QUATTROCCHI KWOK
ARCHITECTS

PARKWAY HEIGHTS MIDDLE SCHOOL MODERNIZATION – PHASE II
PROJECT 01-18

Addendum 02

FEBRUARY 21, 2018

SHEET NUMBER
ADD 02
02.05
C4.1

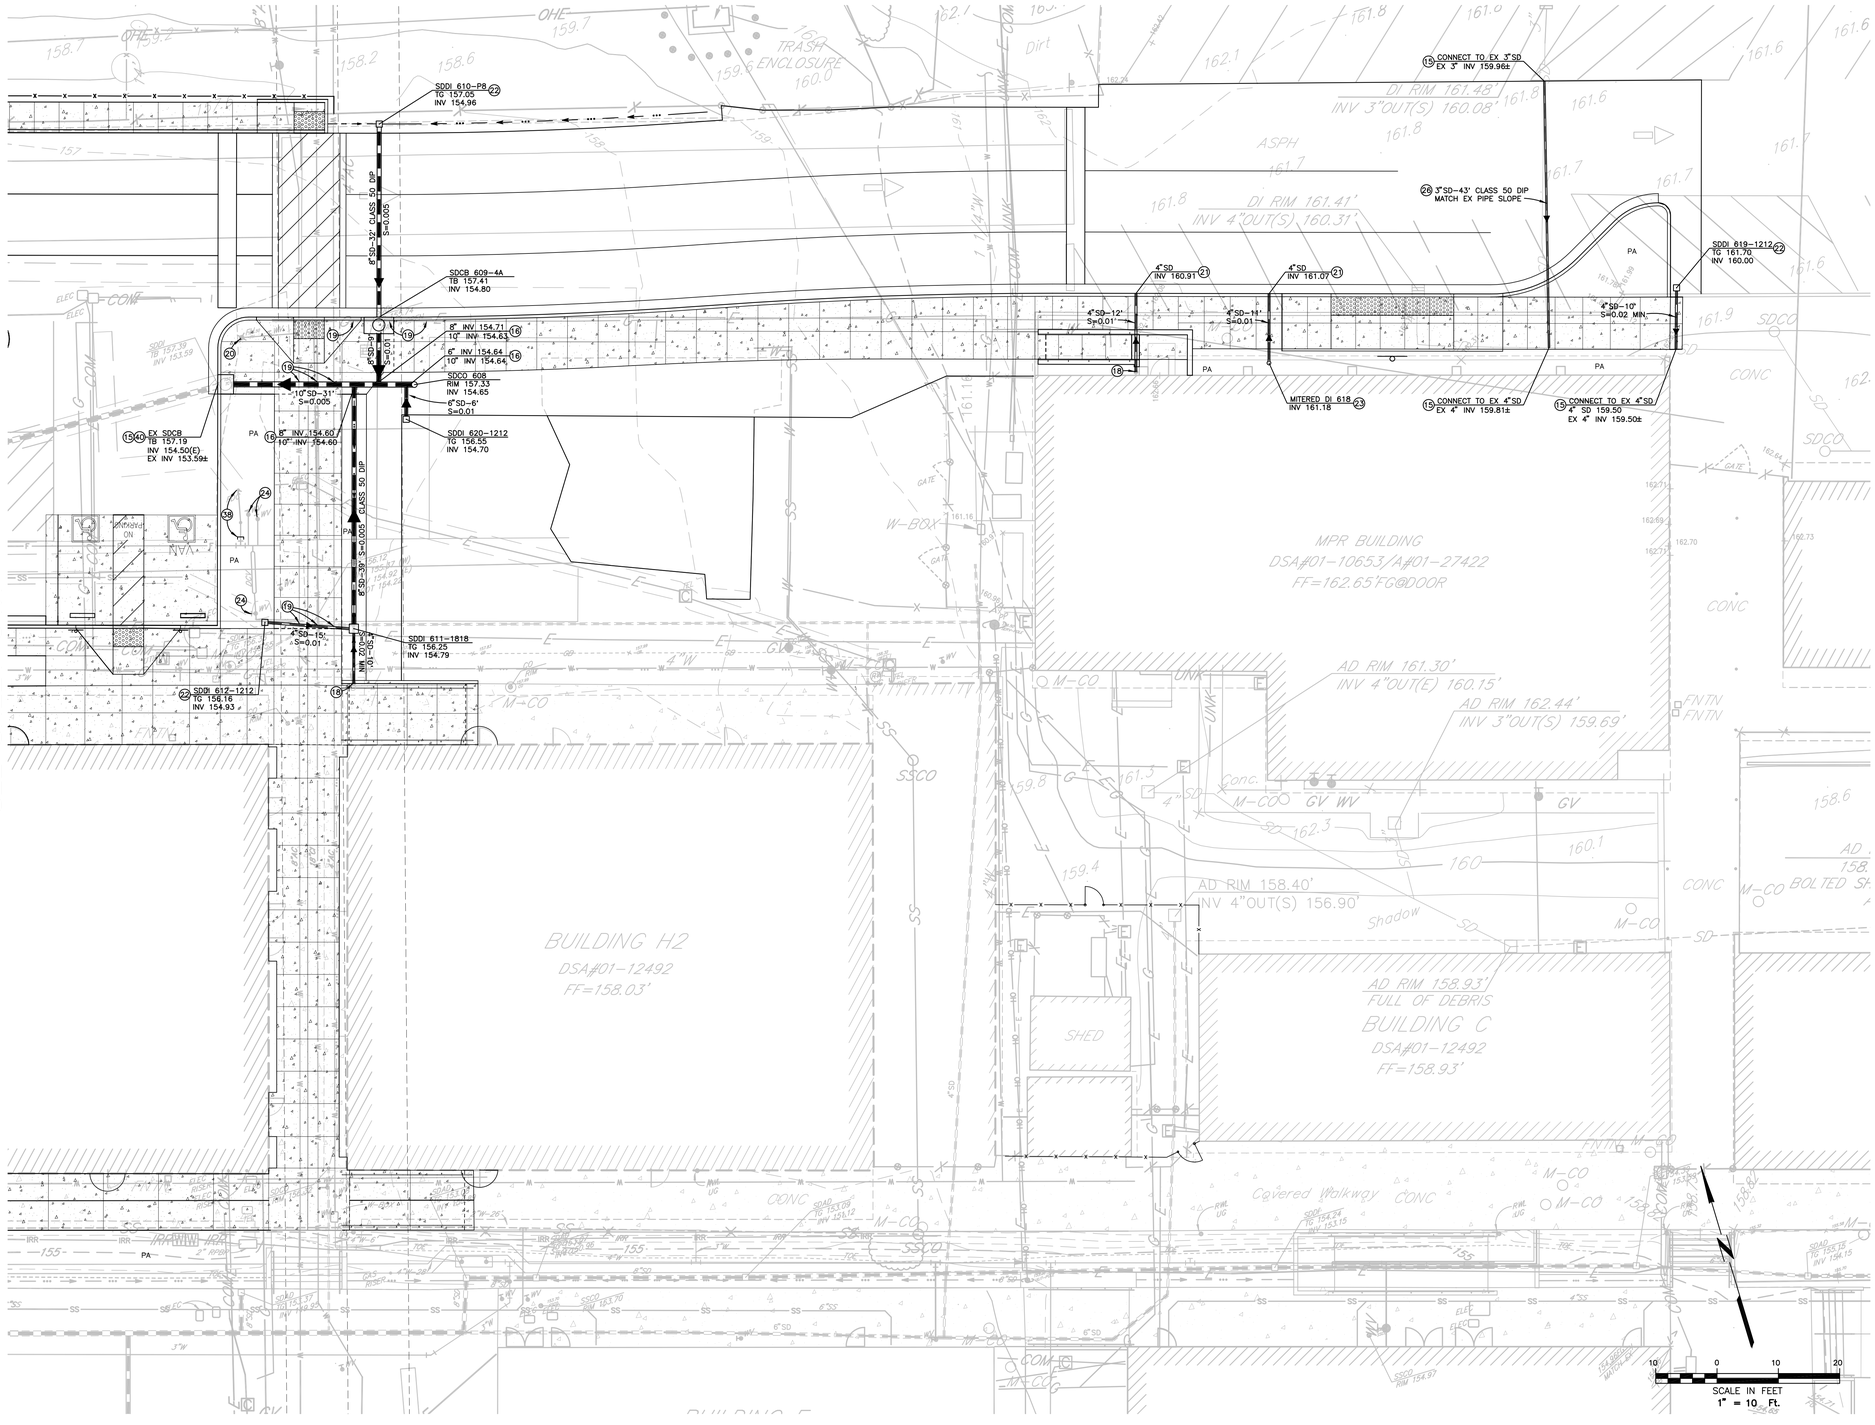
Item No. 2.09
Sheet C4.1 Utility Plan
Modifications from sheet C4 include remove courtyard storm drain improvements, tree planter box sub drain and storm drain inlets. Add SDDI 620 to the northwest corner of courtyard, upsize SDDI 611 to an 18"x18" box, remove atrium grate, upsize SDCB 609 to a 4A box, install 39' of class 50 DIP pipe north of SDDI 611, and install 32' of class 50 DIP pipe north of SDCB 609. See ADD 02.05

SHEET NUMBER
ADD 02
02.07
C6.1

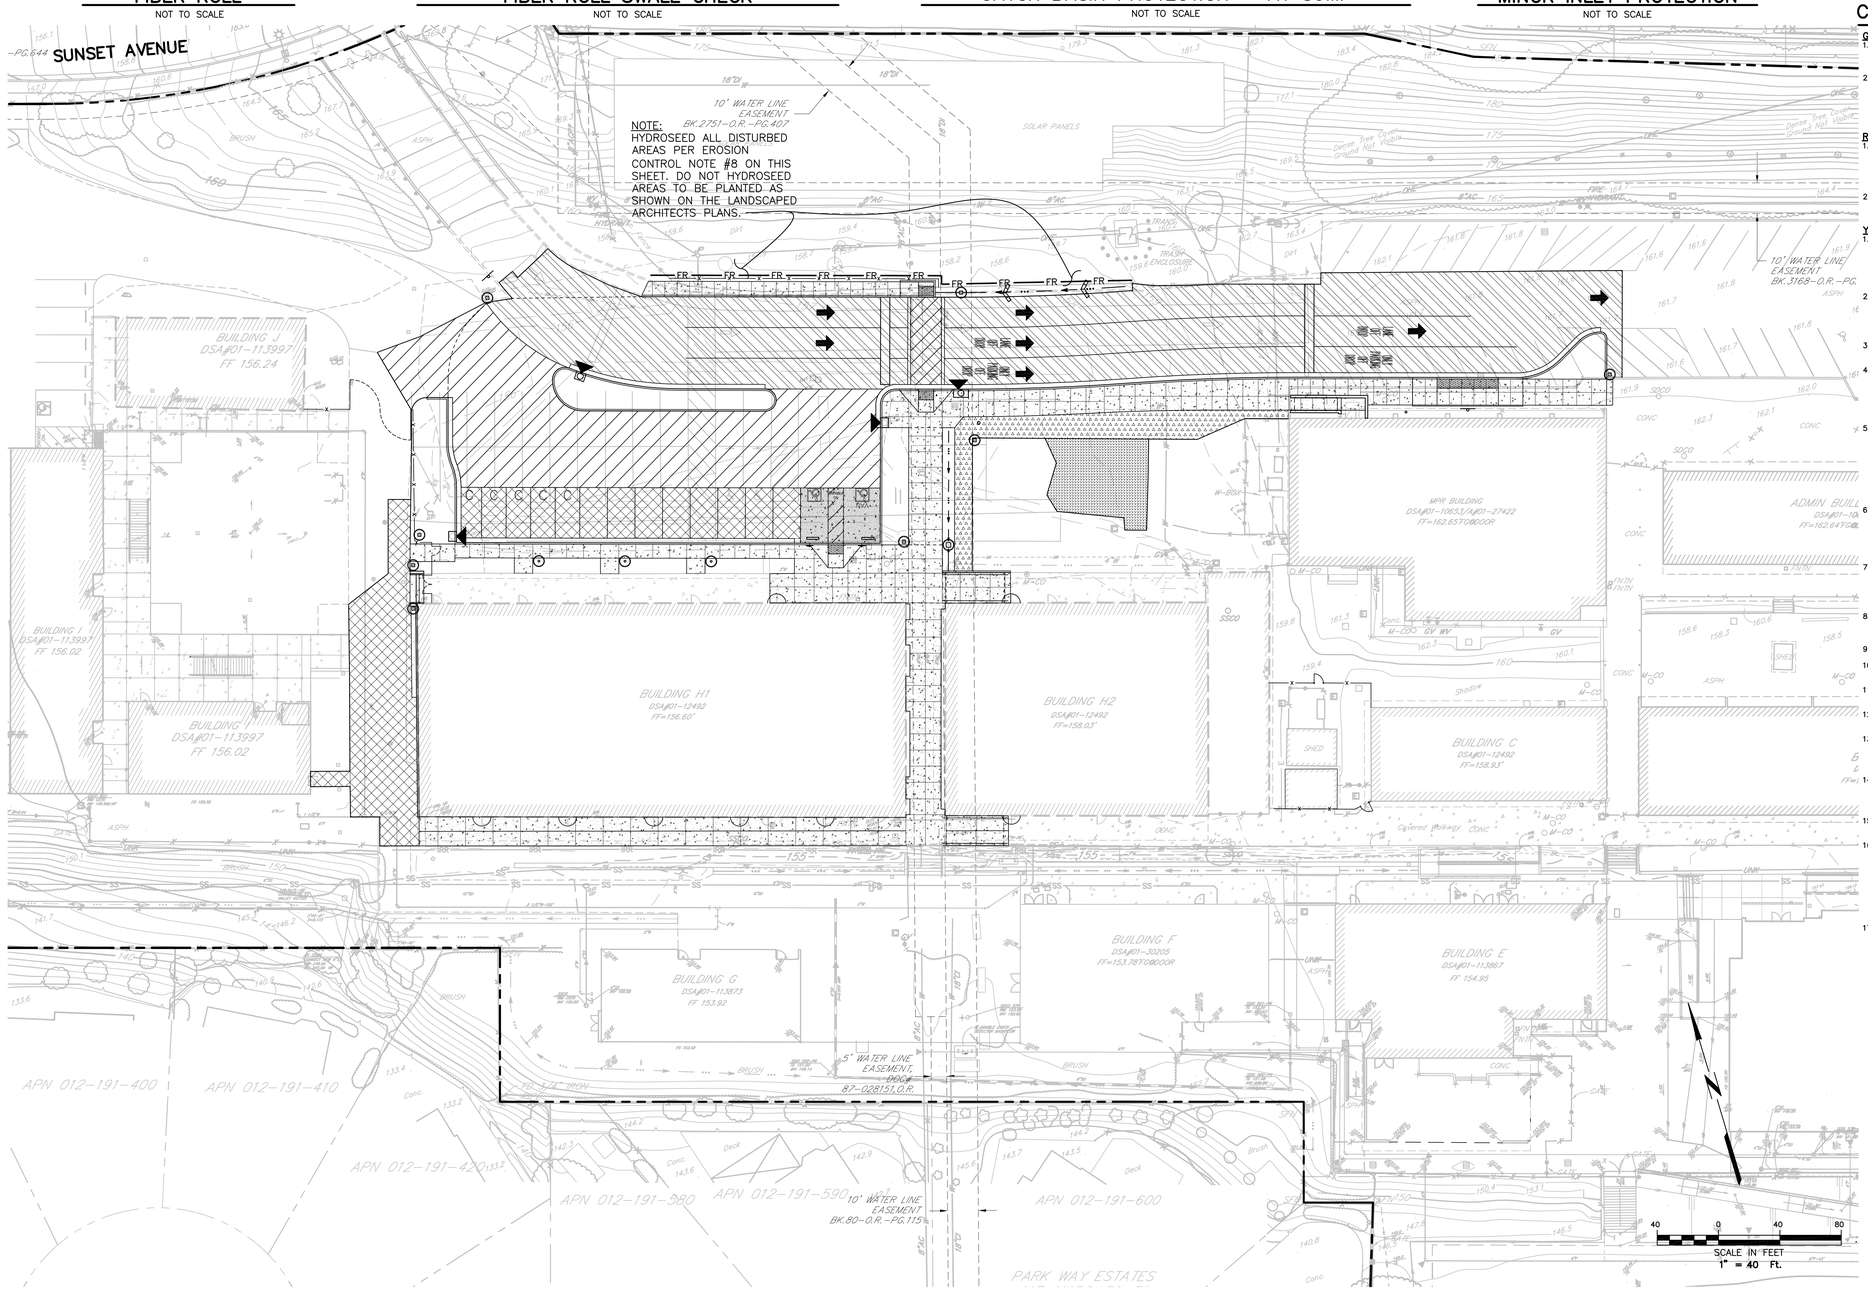
Item No. 2.11
Sheet C6.1 Pavement Structural Section & Erosion Control Plan.
Modifications from sheet C6 include remove courtyard pedestrian concrete paving, add asphalt overlay of area where existing portable existed within courtyard, add courtyard asphalt paving conform from back of sidewalk to existing courtyard asphalt.
See ADD 02.07

SHEET NUMBER
L01.00
ADD 02
02.12

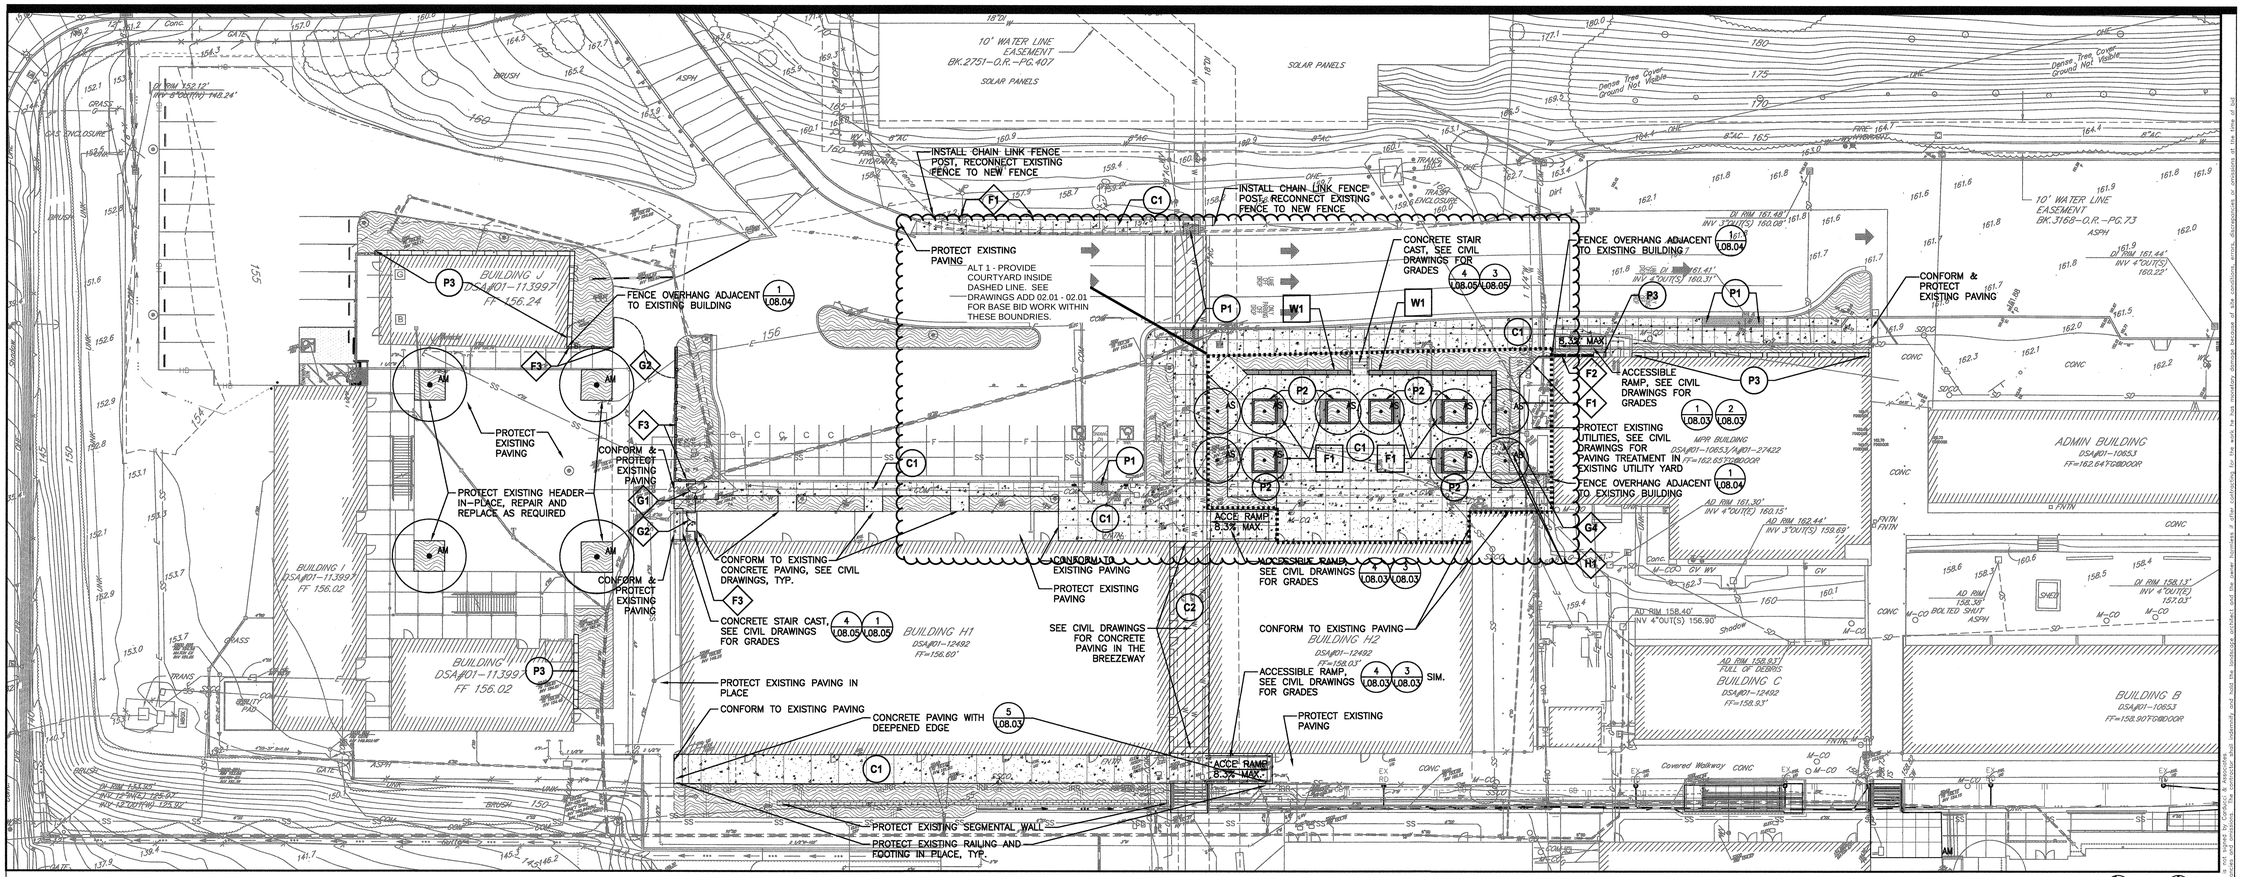
Item No. 2.16
Sheet L01.00 Materials Legend & Plan
Courtyard and north side of MPR building irrigation and planting is alternate 1 work.
For base bid remove courtyard and associated flatwork, walls, stairs/handrails, irrigation and planting within courtyard, as indicated and irrigation and planting along north side of MPR building. See ADD 02.12

L02.00

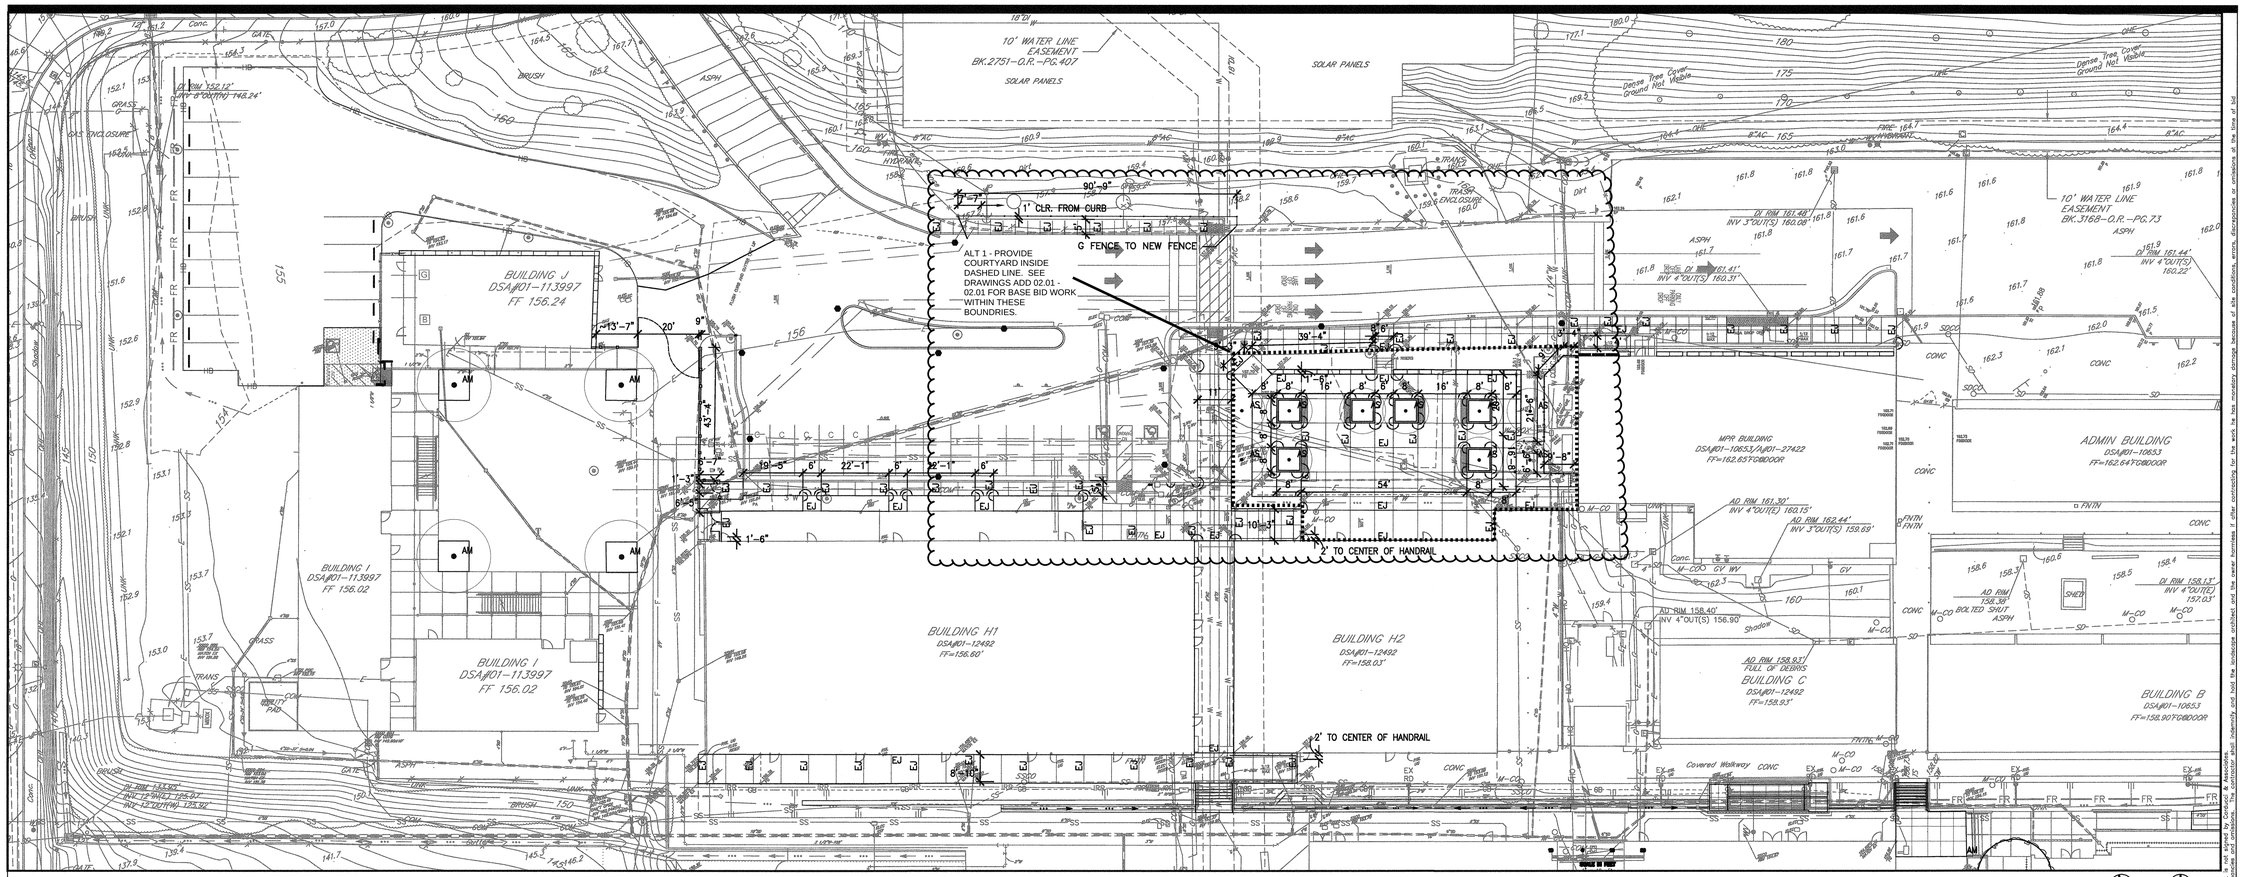
Item No. 2.17
Sheet L02.00 Layout Legend & Plan
Courtyard is alternate 1 work
For base bid remove courtyard and associated flatwork. See ADD 02.13

SITE PLAN - ACCESS

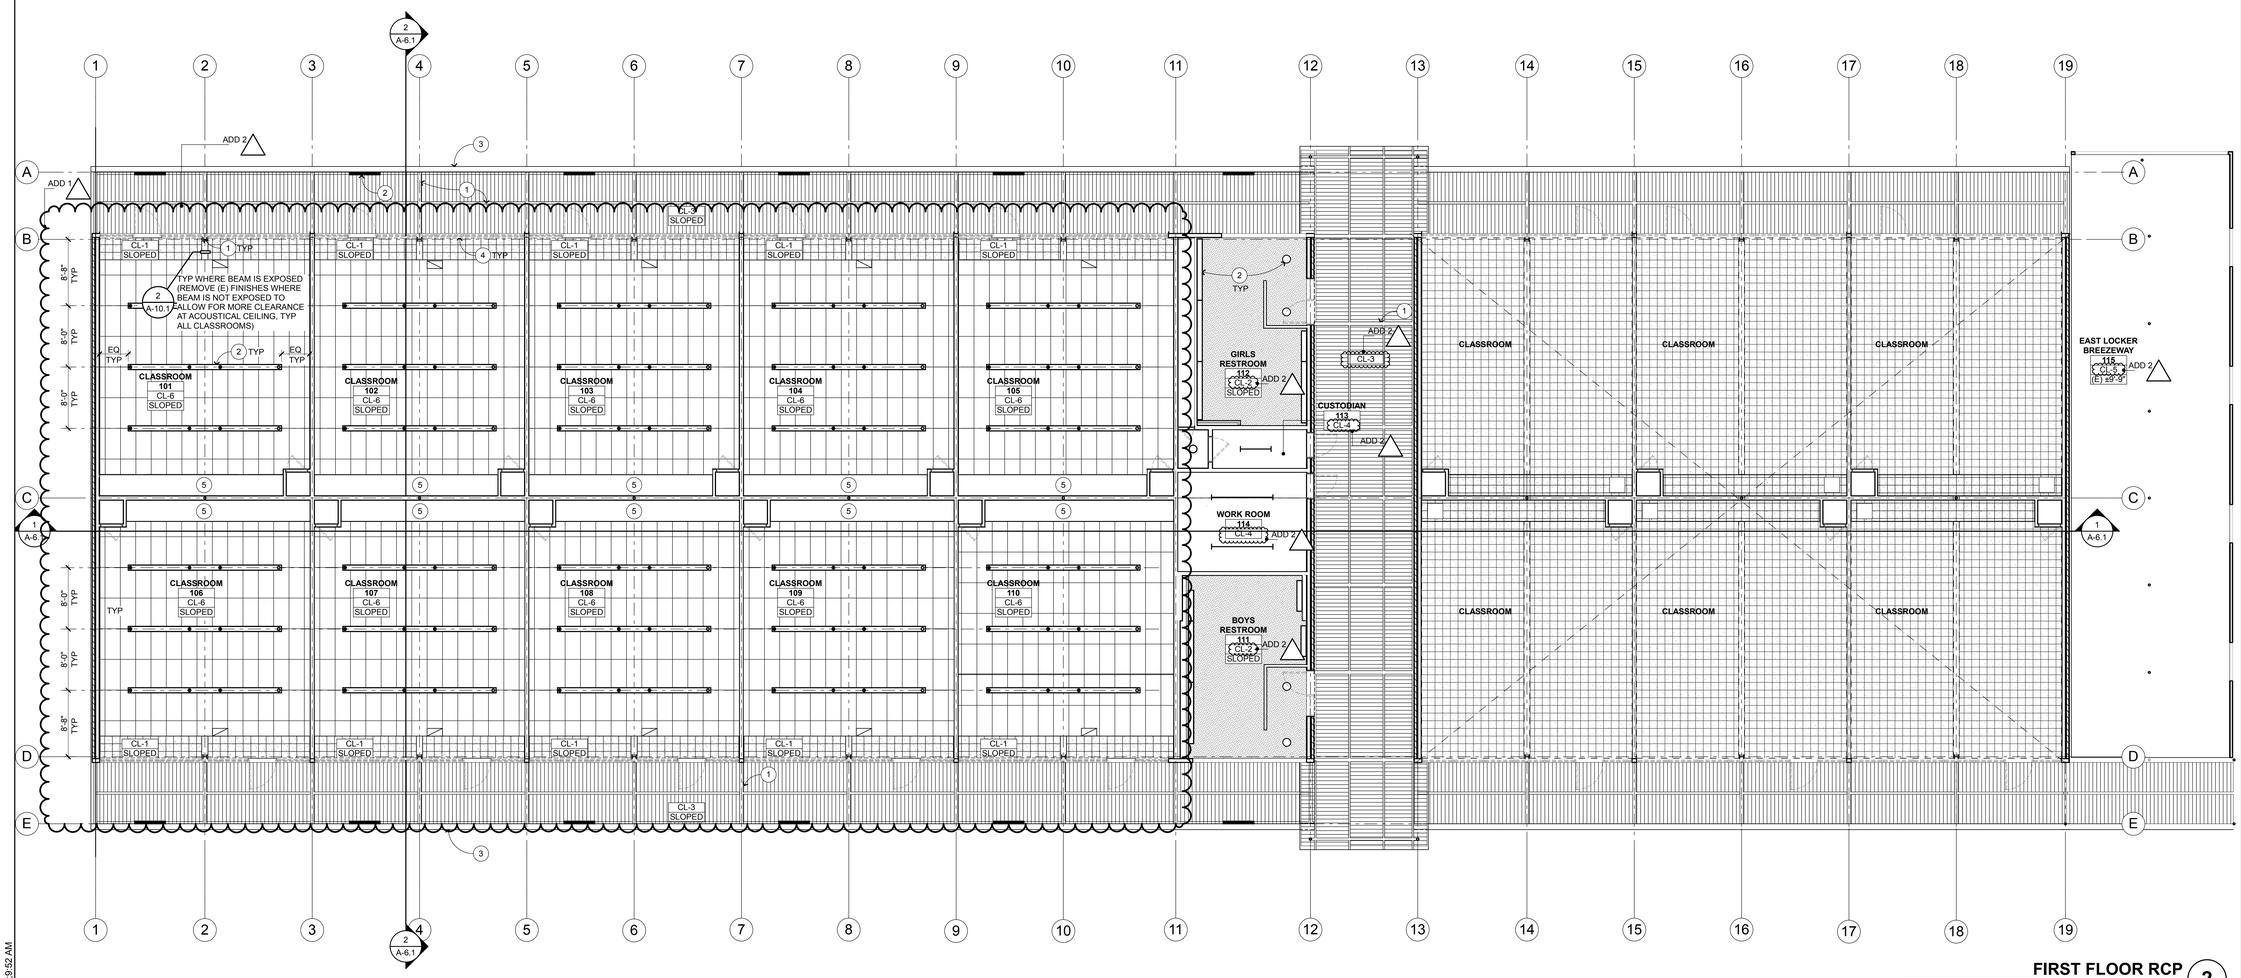
Item No. 2.28
Sheet A-1.1 SITE PLAN – ACCESS
Courtyard improvements indicated within dashed line is Alternate 1 work. Refer to sheets ADD 2.01 – 02.11 for further description of base bid work within dashed line perimeter. See ADD 02.14.
